Urban Design Review Panel Report

Riverside South Community Centre and Library

250 Town Square Place, Ottawa, ON, K1X 0B7

UDRP Meeting date: April 10th, 2026

Building Elevations

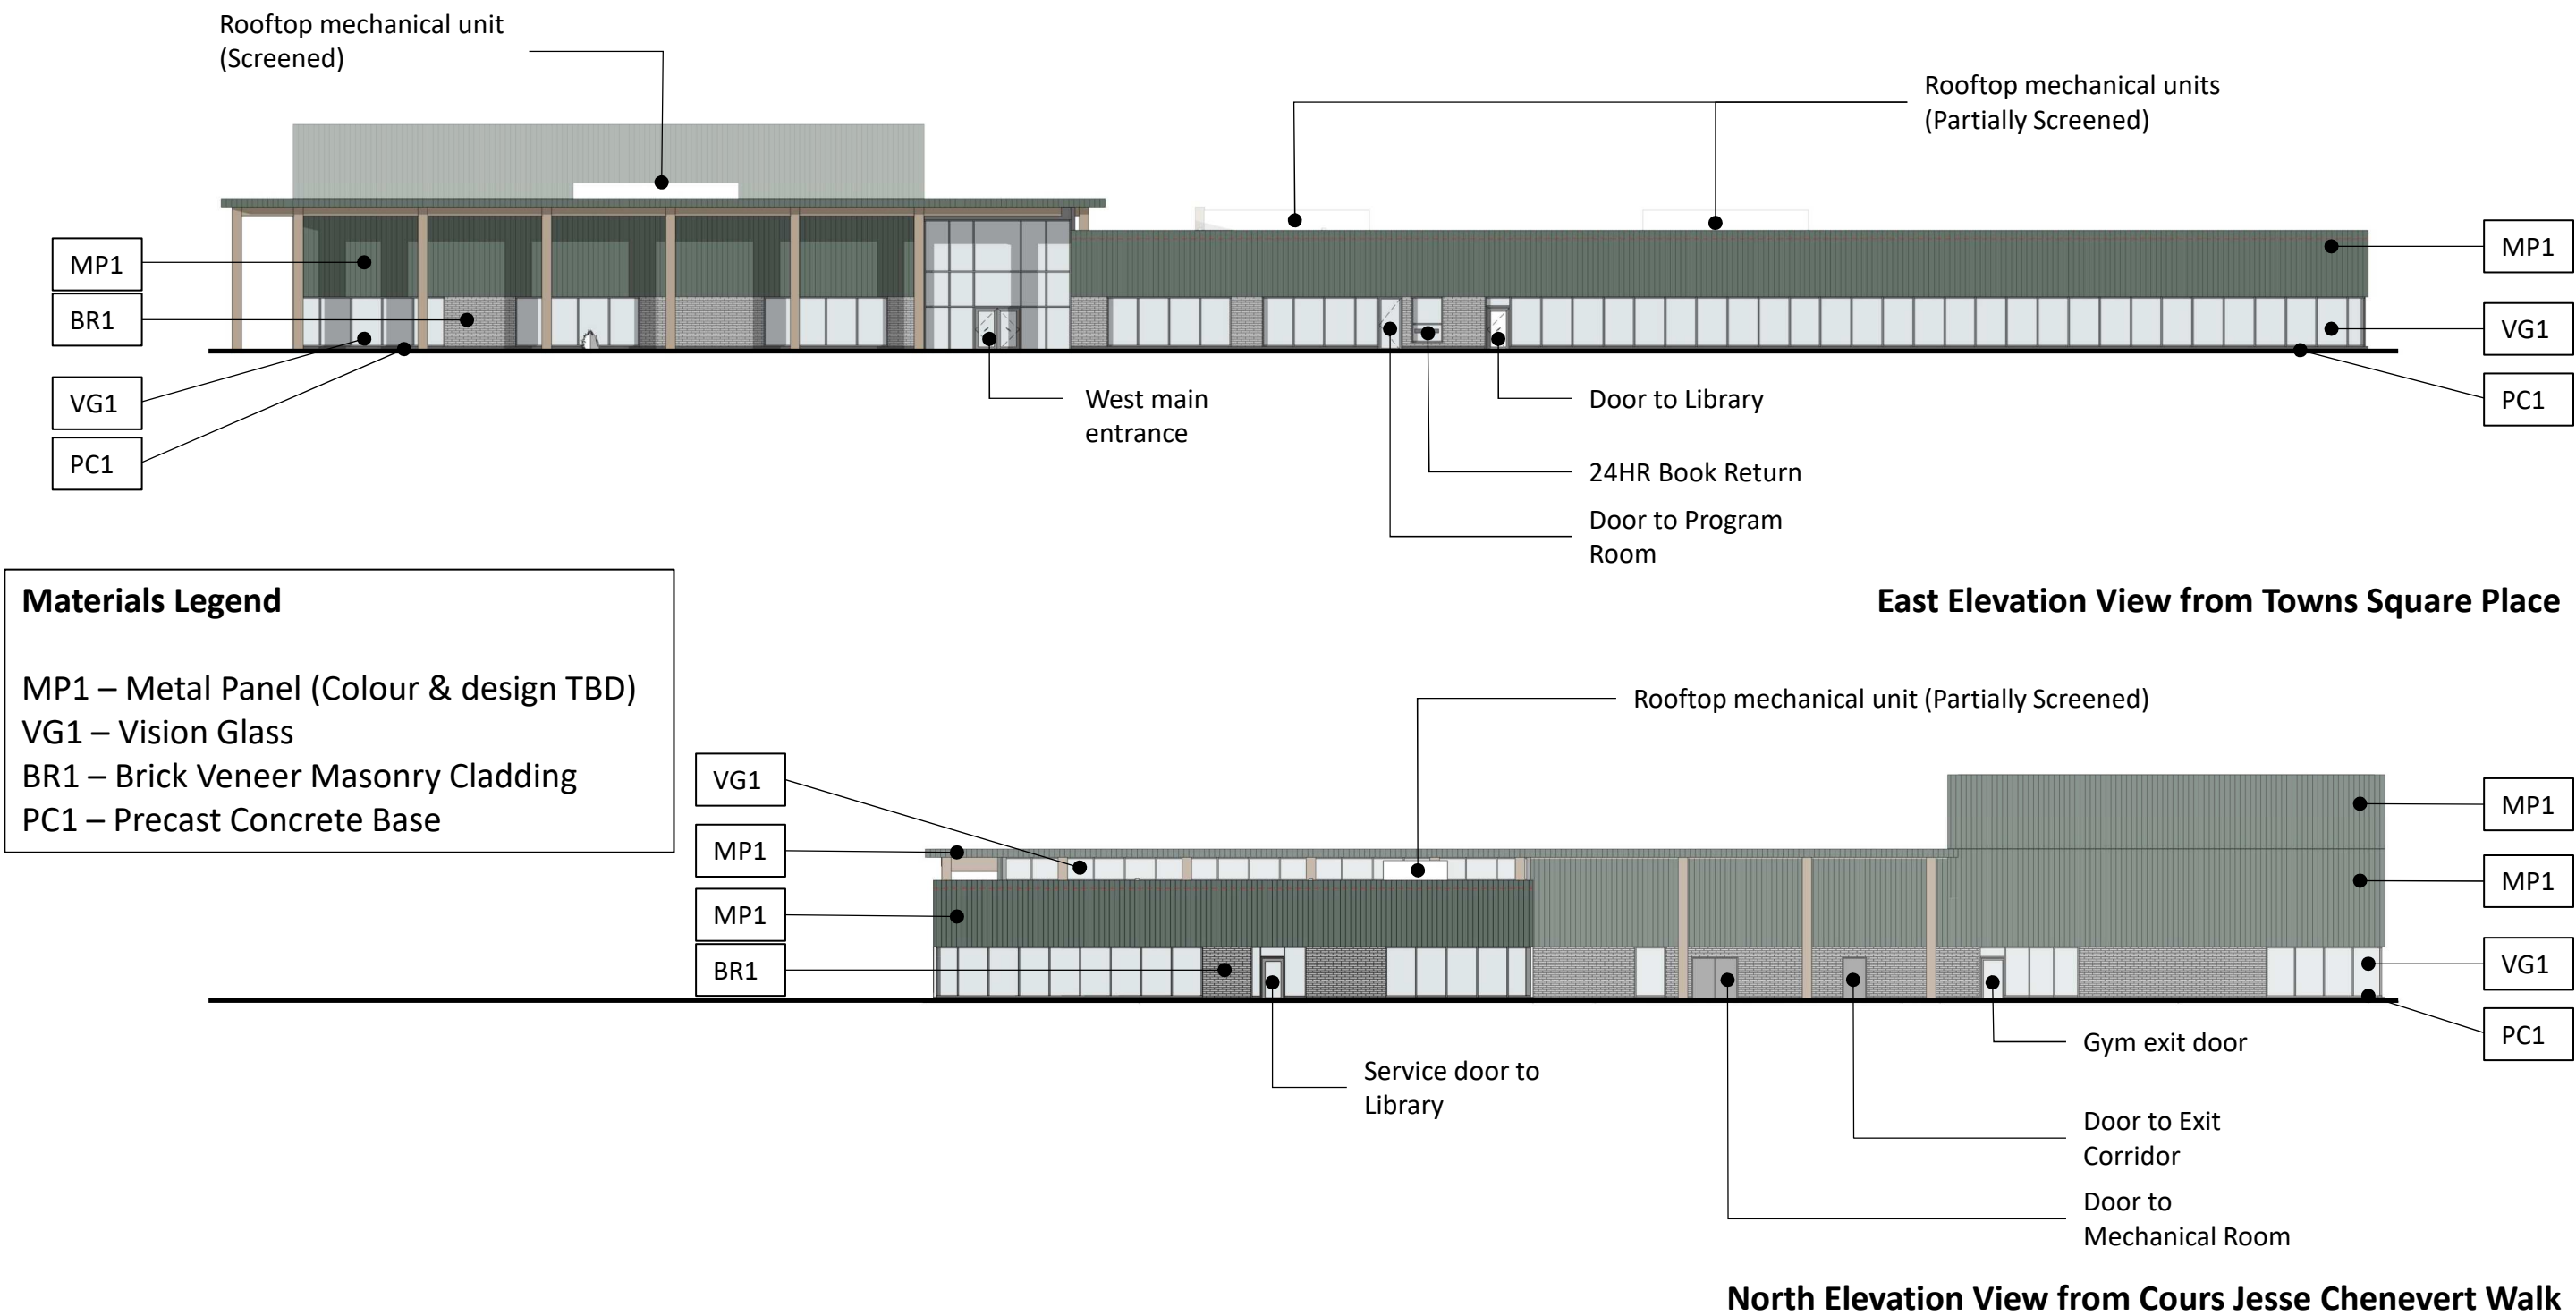
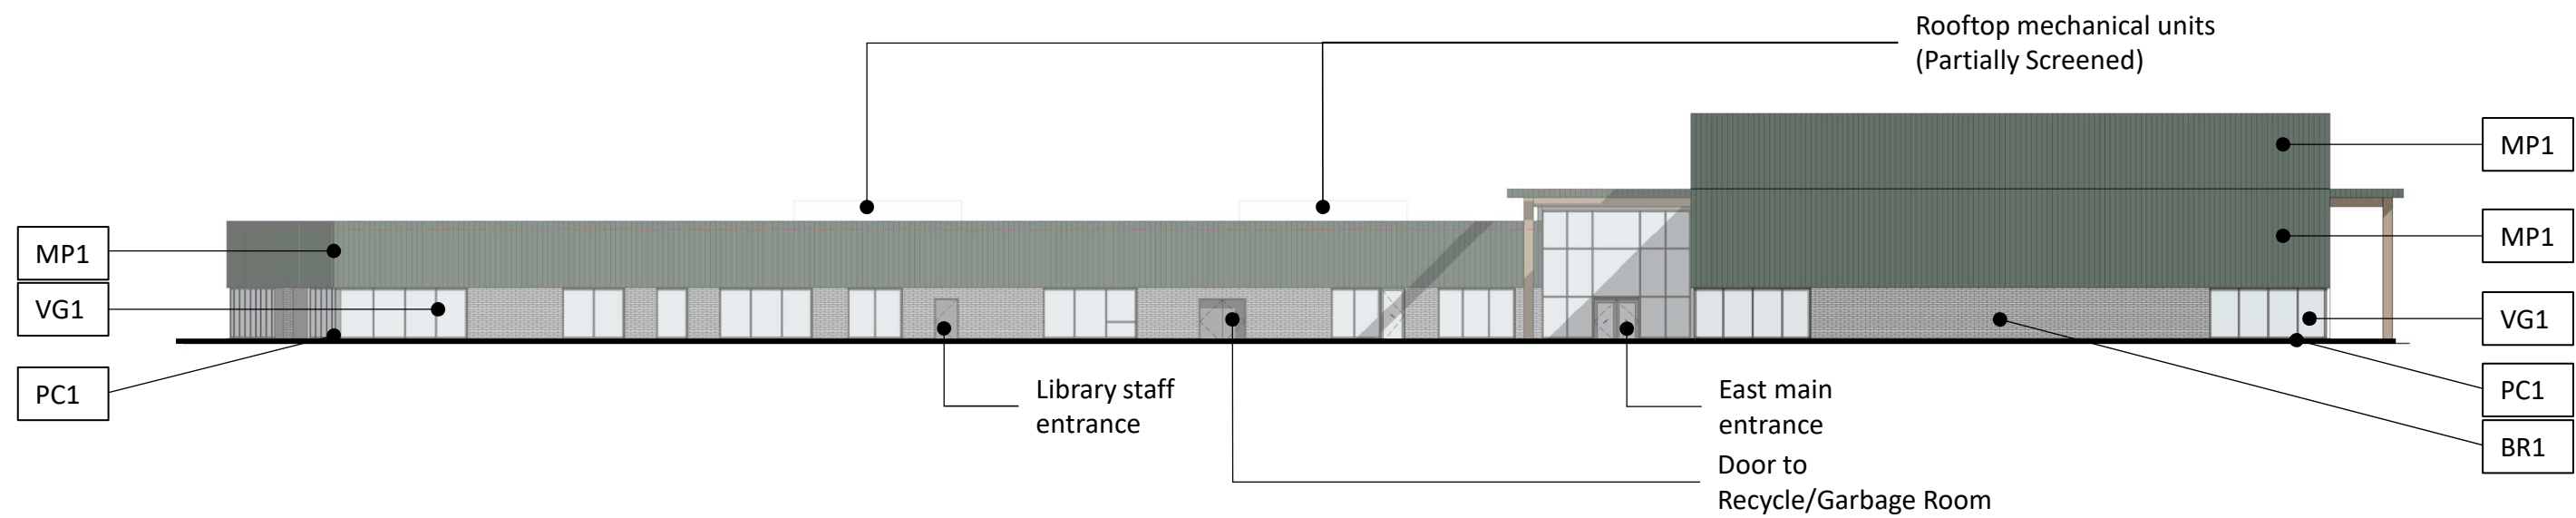
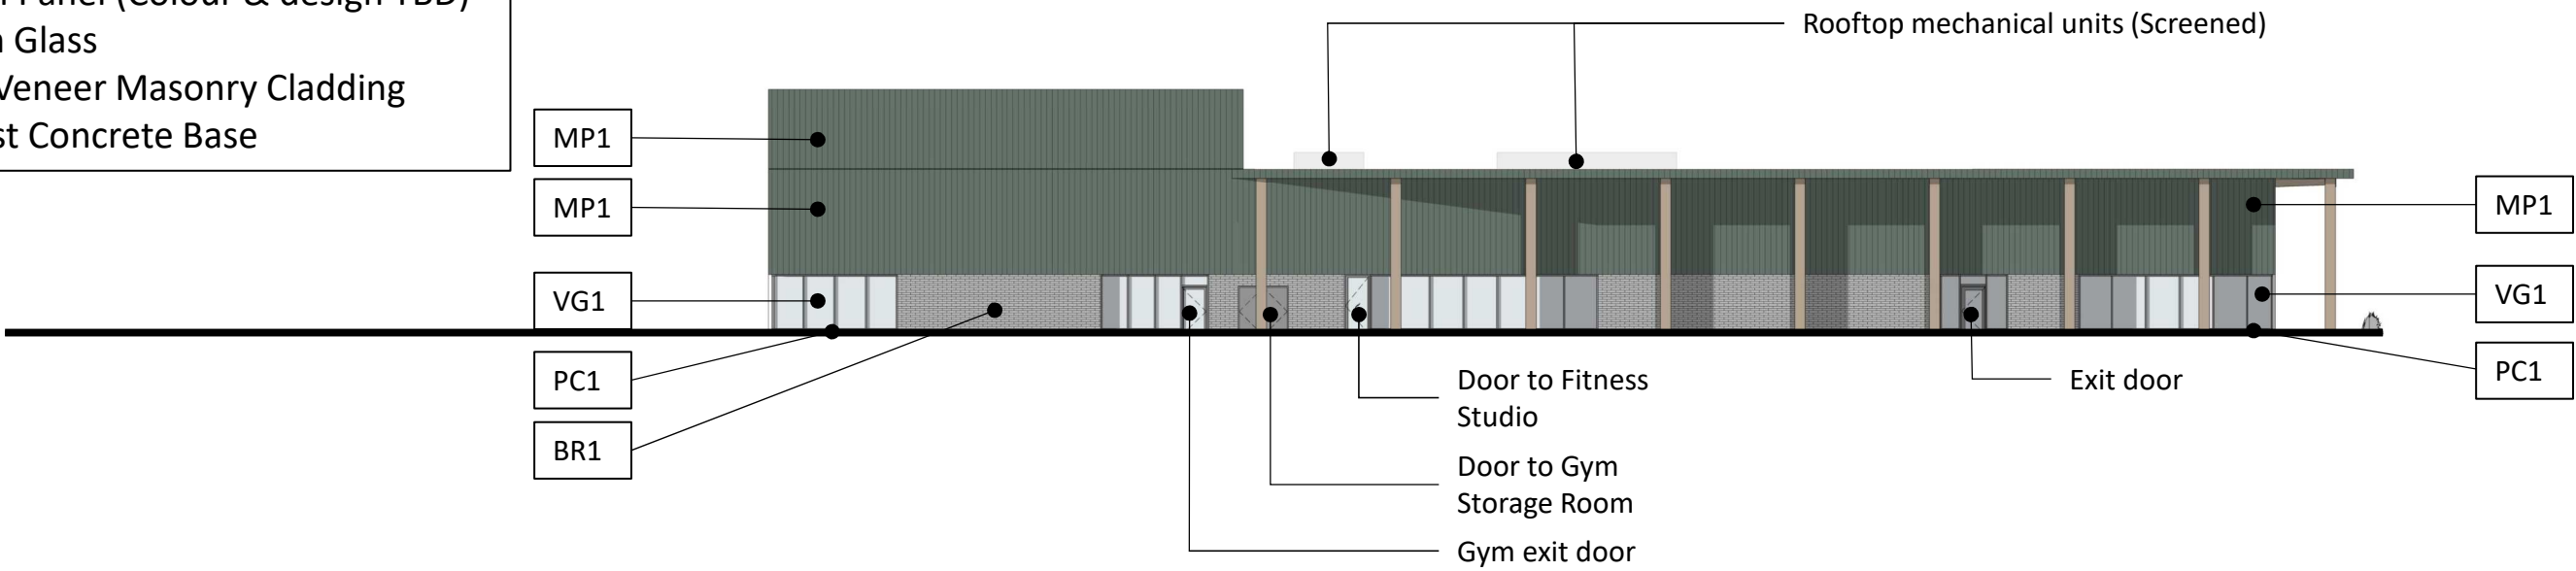
- The Panel expresses strong support for the clarity of the architectural concept, particularly the use of a strong horizontal datum. The elemental approach to architecture is appreciated and encouraged to be maintained as the design evolves.
- The Panel recommends further exploration of the building's public-facing facades to enhance animation and better express interior activity, particularly for the library and fitness areas.
 - Increasing glazing at key locations, including emphasizing the prominent corner condition at the intersection, is encouraged to strengthen visibility and connection to the public realm.
- The Panel notes that the horizontal datum may overemphasize the upper cladding and suggests adjustments to better highlight ground-level activity.

- The Panel emphasizes the importance of high-quality metal panel detailing, including jointing, banding, and modulation, as well as careful consideration of color variation to avoid a flat or overly dark appearance.

- The Panel also encourages exploration of vertical elements within the composition to complement the strong horizontal expression, particularly at entrances, to reinforce the building's landmark presence.

As noted, the strong horizontal datum is integral to the clarity of the architectural concept, however some refinement is recommended to prevent the metal-clad upper section from overwhelming the lower glazing and interior activity.

The previous vertical metal panel design emphasized the verticality of the upper level, visually extending the height and 'weight' of the upper level. The redesigned metal panel option is based on a diamond tile pattern that reorients the vertical joint lines by rotating them 45

degrees and visually minimizing the height of the upper layer. The vertical breaks in the horizontal datum are focused on the full height curtain walls of the main Lobby. These breaks in the building mass visually connect the future urban realm of Town Square Place through to the park beyond with the Lobby acting as the building's central connecting point.

A colour gradient has been introduced in the diamond tile pattern in an intentionally randomized pattern with darker green panels starting out from the Lobby that gradually dissolve into lighter shades of green at the building corners, animating the façade and relieving some of the visual weight, particularly at the largest volume facing the park that is the gym.

Town Square Place Streetscape Plan

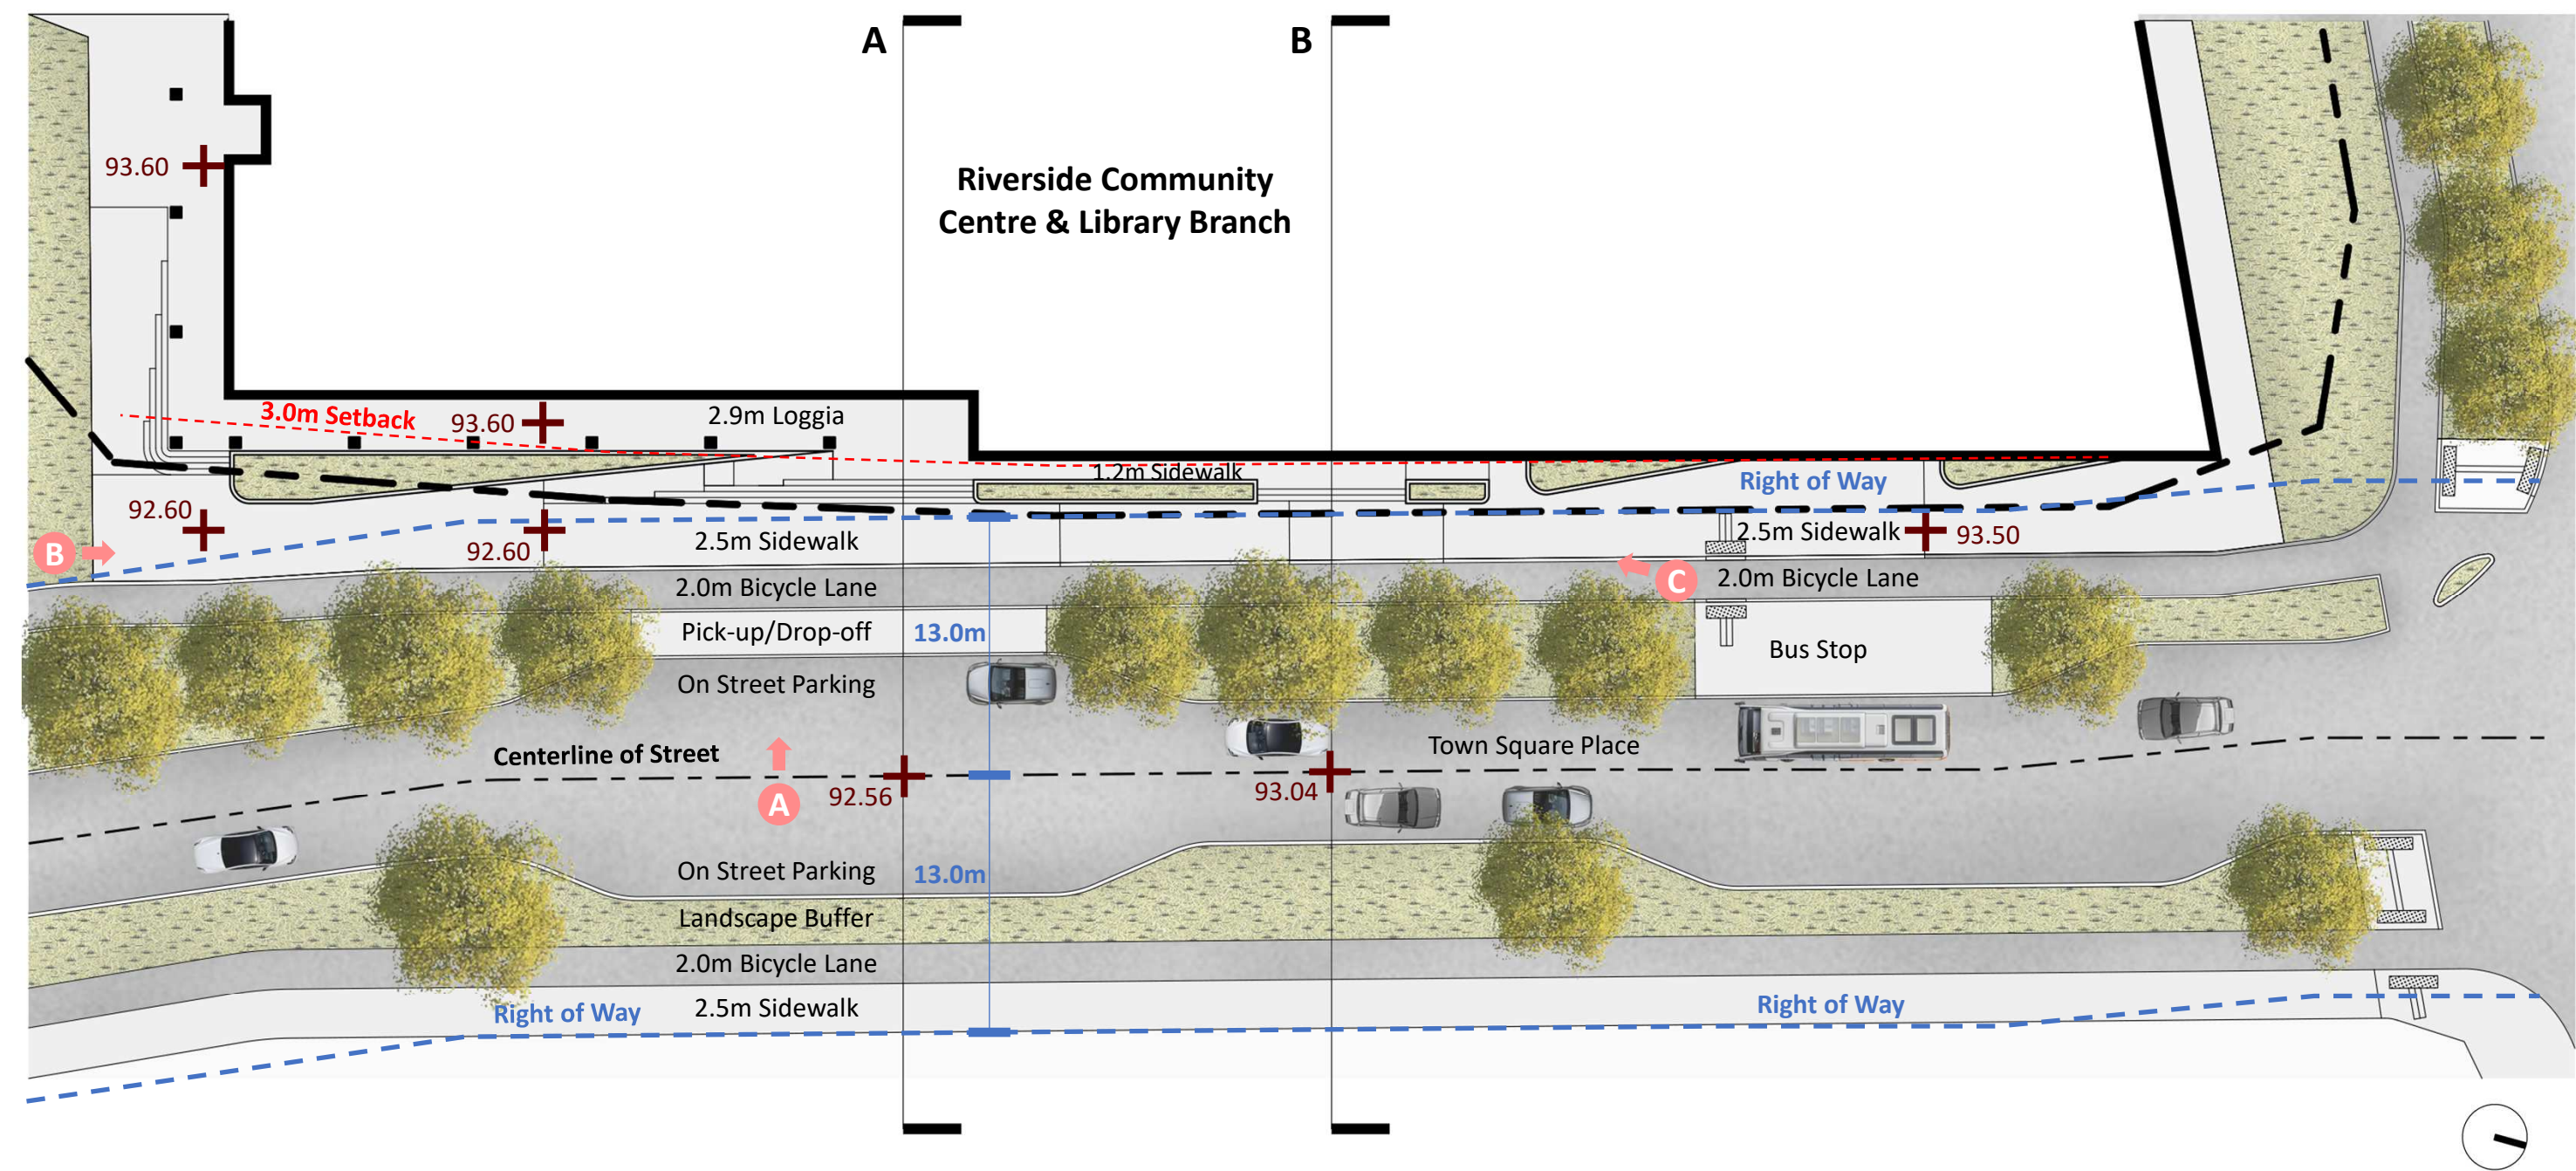
- The Panel recommends further exploration of the site planning approach to provide additional breathing room around the building, particularly along the Town Square Place frontage.

- The Panel supports the overall site organization and appreciates the pedestrian connection that divides the community centre and library components.
- The Panel recommends exploring opportunities to increase the setbacks and provide additional space along the street edge to create a more generous public realm.

- The Panel notes accessibility challenges at the southeast corner due to grade change and a constrained drop off area. Reducing stairs and increasing the setback may help address these issues.

In coordination with the clients (RCFS and OPL) and the City's Development Review group, the public realm along Town Square Place (TSP) has been redesigned to:

- Increase the setback by roughly 2m to allow for a more generous entry plaza, sidewalk, drop off, and seating along TSP.
- Reduce the exterior stairs by one step (due to increased setback)
- Collocate the main stair and ramp entrances, creating an intuitive, equal, and dignified access to all users, better defining the sequence to, and arrival at, the main entrance.
- Increase the width of the planting beds along TSP and integrate columnar trees in the bed facing the portico/canopy, visually extending a more generous planted landscape around the building to the main street.

- Slope the planter bed retaining walls down to streetside reducing the height at the widened sidewalk allowing for integrated benchtops along TSP.
- The integrated landscape design improvements noted above, and increased set back create a generous and animated arrival sequence approach from the LRT.
